Work Order ID 88800

Item Name: Replacement Skidtube

DRAWING NO. D2580	TITLE 205 SKIDTUBE ASSEMBLY	REV. E	<b>DART AEROSPACE LTD ENGINEERING ORDER</b>	D.E.O. NO. D2580-E-1	SHEET NO. SHEET 1 OF 1	SCALE NTS
DRAWN <i>UP</i>	CHECKED <i>ASS</i>	MFG. APPR. <i>E</i>	APPROVED <i>#</i>	DE APPR. <i>#</i>		
DATE 11.12.13	DATE 11.12.13	DATE 11.12.13	DATE 11.12.13	DATE 11.12.13	DATE 11.12.13

CHANGE ALL C'BORED WELDED CROSSBOLT SPACERS TO SWAGED SPACERS

**SECTION B-B, F-F, I-I**  
NOT TO SCALE

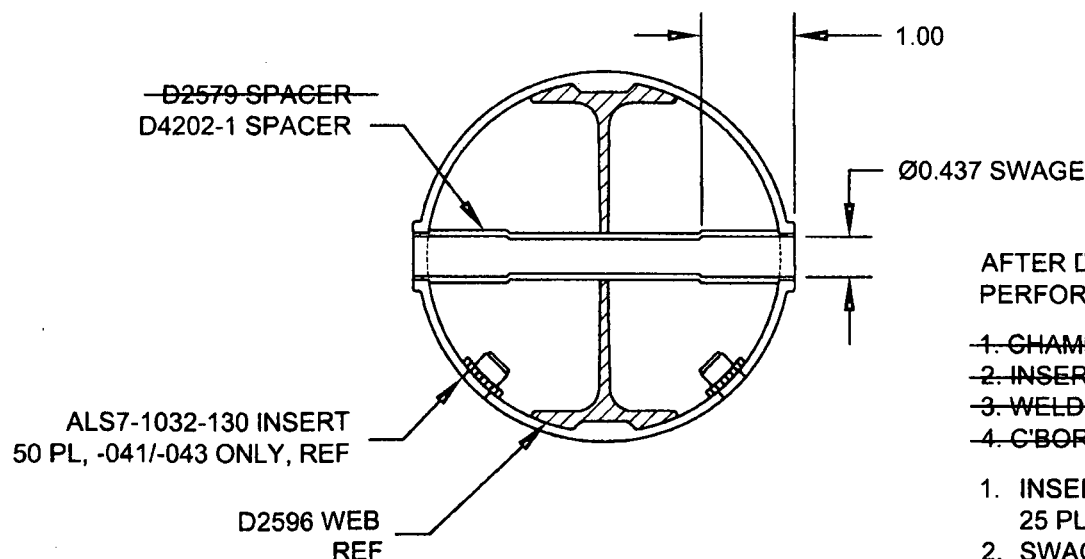
PARTS LIST IS AMENDED AS FOLLOWS:

WAS

QTY	QTY	QTY	PART NUMBER	DESCRIPTION
-041	-045	-047		
20	24	25	D2579	CROSS BOLT SPACER

IS

4		* D2579	CROSS BOLT SPACER
20	20	25	D4202-1	SPACER

SECTION B-B, SECTION F-F, & SECTION I-I ARE AMENDED AS FOLLOWS  
FOR ALL HOLES THAT WERE ORIGINALLY C'BORED:

**\* FOR -045 SKIDTUBE ONLY:**

WELD 4X D2579 SPACERS PER DWG  
IN LOCATIONS MARKED "NO C'BORE".  
REF SHEET 4 OF DWG.

AFTER DRILLING AND BENDING ASSEMBLY  
PERFORM THE FOLLOWING FOR Ø0.508 HOLES ONLY:

1. CHAMFER HOLE 0.050 X 45°
2. INSERT D2579 SPACER (20 PLACES)
3. WELD INTO PLACE AND GRIND FLUSH
4. C'BORE D2579 SPACER TO Ø0.437 X 1.00 DEEP

1. INSERT D4202-1 SPACER, 20 PL (-041) OR 20 PL (-045) OR 25 PL (-047)
2. SWAGE TO Ø0.437 X 1.00 DEEP PER QSI 002
3. TRIM / GRIND FLUSH PER QSI 002
